# RADIO CORPORATION PTY. LTD. Bulletin: HQ-2

## 6BE6 CONVERTER TUBE

The type 6A8G converter tube used in the Model "HQ" receiver has been changed to a type 6BE6 converter tube.

#### 6BE6 SOCKET CONNECTIONS

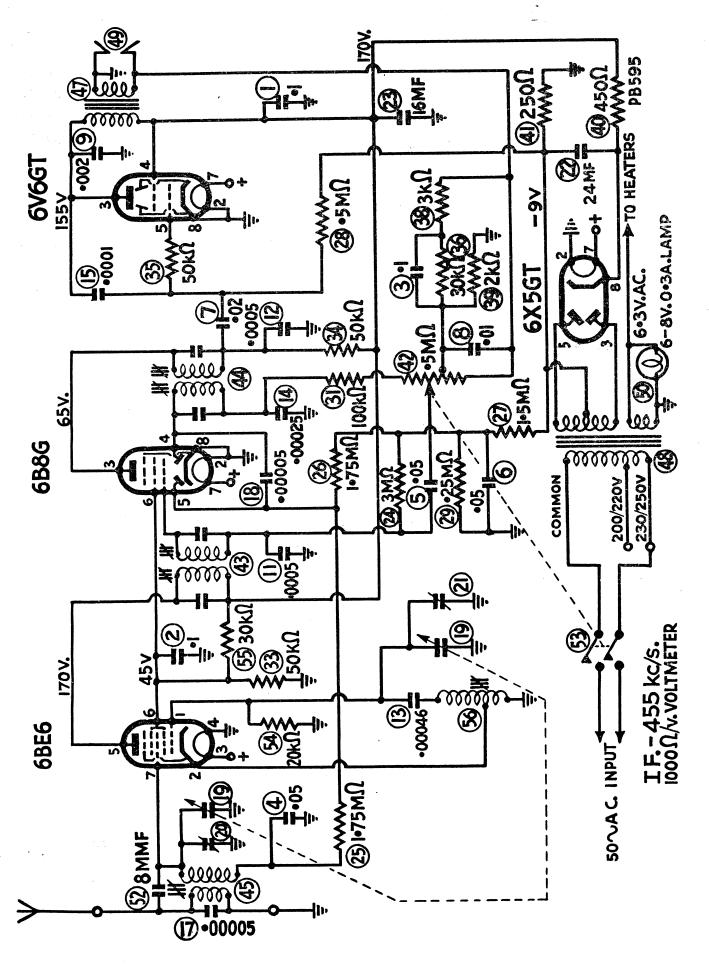
A new circuit using a 6BE6 tube in the converter stage is shown on page two of this service sheet.

The socket connections and new components required for the 6BE6 tube and the connections for the new oscillator coil are detailed below:--

Pin	No.	l.	Oscl. grid	Pin 1	No.	4.	Heater
,,	,,	2.	Cathode	,,	"	5.	Plate
,,	,,	3.	Heater	"	"	6.	Screen

Pin No. 7. Signal grid
